ASSESSMENT REPORT

WAMBO COAL MINE Longwall 10A Modification (DA 305-7-2003 MOD 14)

Figure 3 – Layout of proposed Longwall 10A and approved North Wambo Underground Mine workings

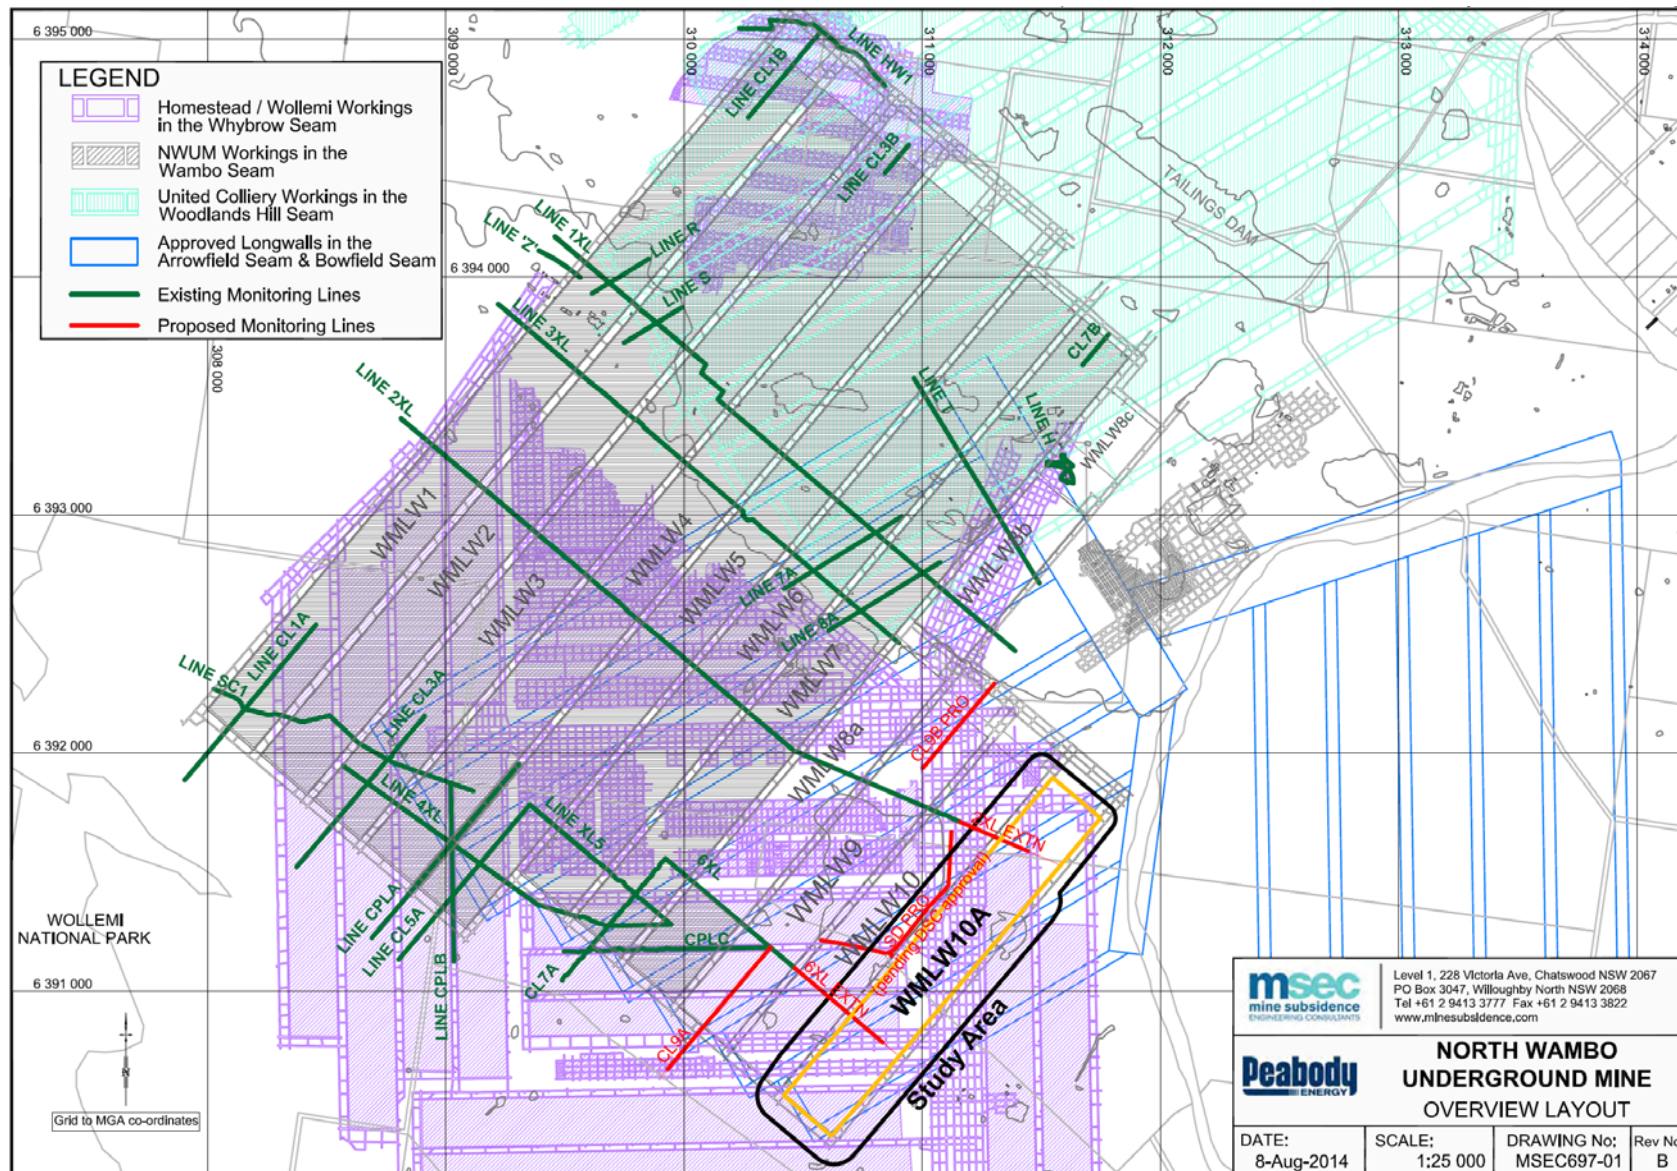
The subsidence assessment accompanying the EA defines the subsidence impact zone associated with the modification, as being the greater of the 20 mm predicted subsidence contour and a 26.5 degree angle of draw from Longwall 10A. As shown in **Figure 3**, this area is located entirely within Wambo-owned land and extends beneath the Wambo and Stony Creek alluvium.

Since the modification area is already subject to multi-seam mining, the key factor for consideration is the relative increase in cumulative subsidence associated with the interaction of previous mining in the Whybrow seam, proposed mining in the Wambo seam and future mining in the Arrowfield and Bowfield seams. Under the modification, the cumulative impacts overlying Longwall 10A would include maximum vertical subsidence of up to 9,700 mm and associated tilts of up to 110 mm/m. These impacts are similar to those for the approved Longwalls 1-10 and would be expected where overlapping extraction is scheduled to occur in all four target coal seams.

Figure 4 – Major surface water drainage systems and extent of associated alluvium

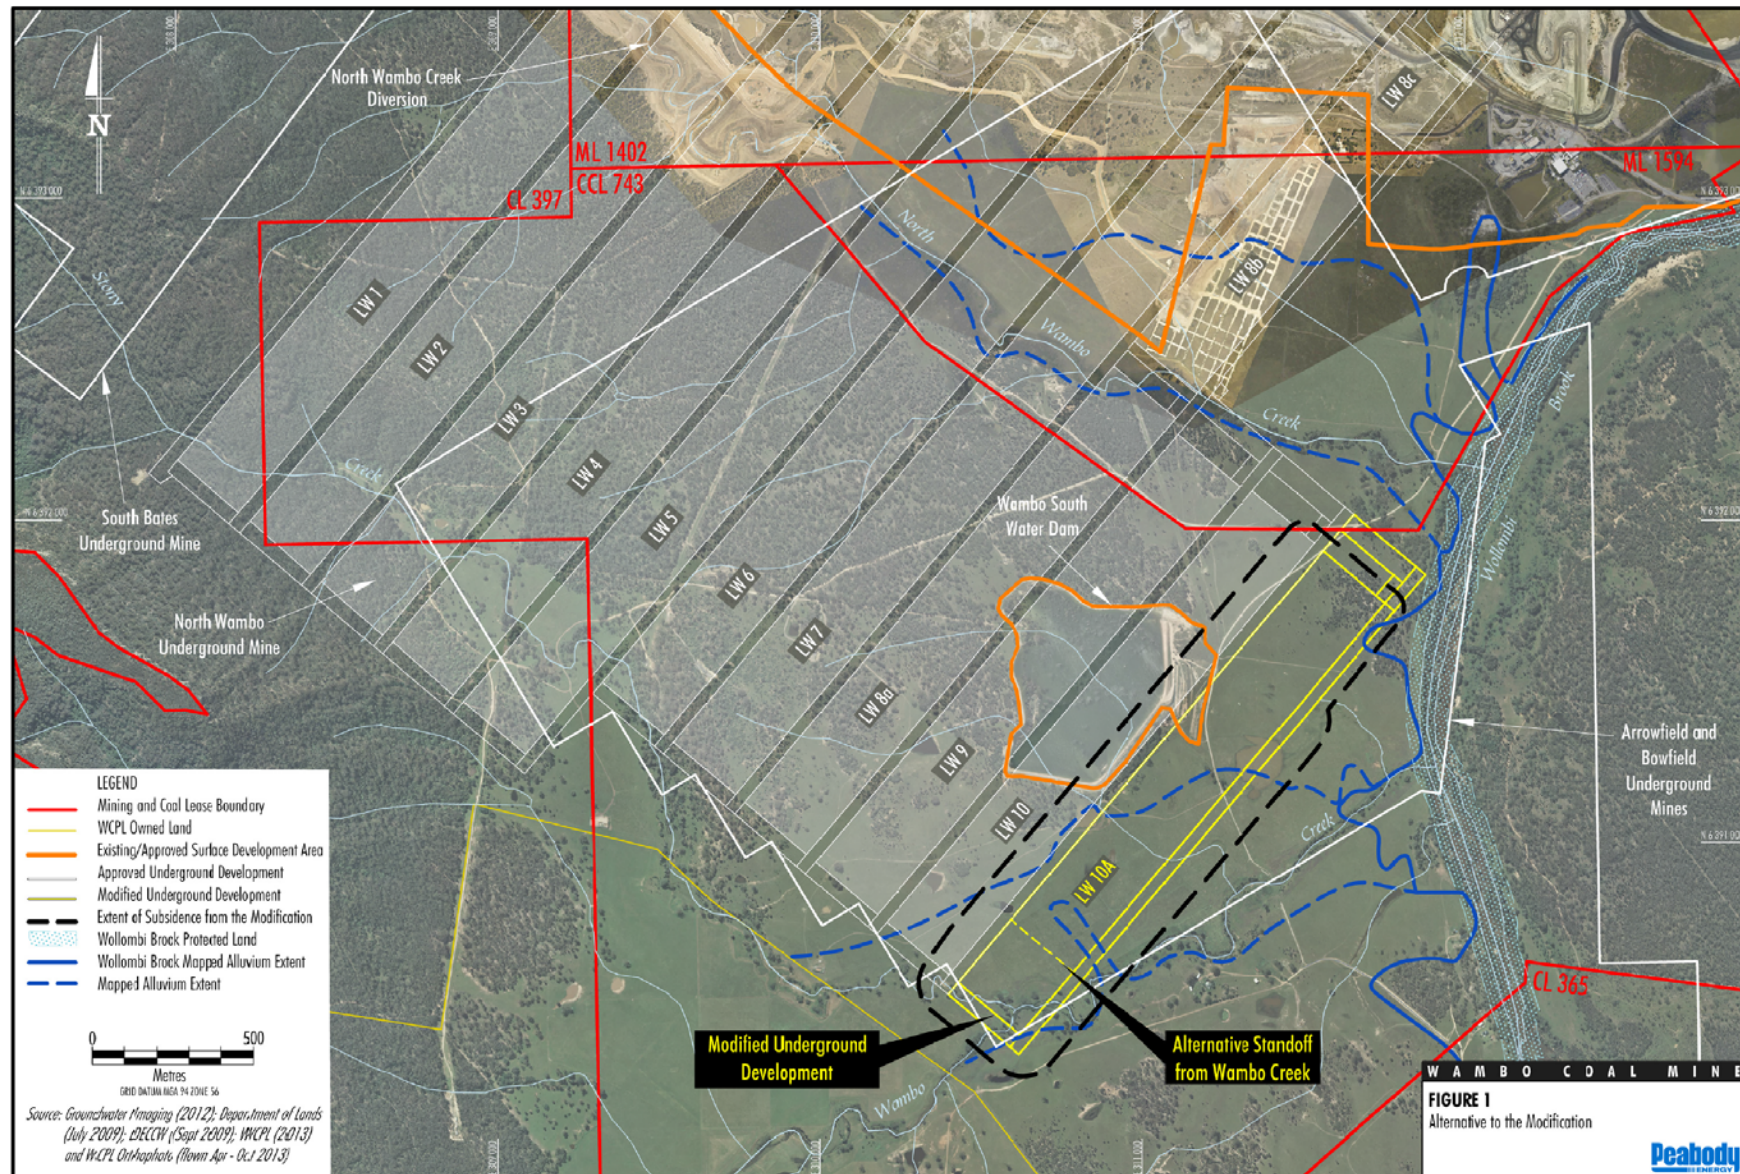
The existing Wambo and Stony Creek watercourses have been significantly affected and degraded through a combination of historical mining-induced subsidence and agricultural practices. Given the poor geomorphic condition and low recovery potential of these watercourses, NOW initially recommended that Wambo avoid undermining directly beneath the creek channels and associated alluvium, to mitigate the risk of any further degradation.

While Wambo owns the land that would be subject to these impacts, the RTS considered various ways to mitigate the impacts on these creeks, including the implications of shortening the longwall panel by 245 m to avoid undermining of the Wambo Creek channel (see **Figure 4**). This alternative setback at the commencing end of the longwall would significantly reduce the predicted subsidence impacts directly beneath the creek channels and some, but not all, of the associated alluvium.

NOW has since confirmed that this setback provides an acceptable compromise, as it would avoid undermining beneath the channels of Wambo and Stony Creek. Notwithstanding, NOW noted that Wambo should be required to monitor and remediate any subsidence impacts on these channels.

The Department has considered this alternative setback carefully and notes that it would involve the sterilisation of around 262,000 tonnes of ROM coal, which equates to about \$13.5 million in lost revenue. However, on balance, the Department believes that the protection afforded by this setback has merit and has recommended that it be imposed through a condition of consent.

Further, with the amended setback for Longwall Panel 10A shown in **Figure 4**, the modification would no longer involve secondary extraction beneath the *River She Oak riparian woodland* and threatened *Hunter Lowlands Red Gum Forest* DGEs known to occur along Wambo and Stony Creeks, and is unlikely to result in material incremental subsidence impacts on these communities.
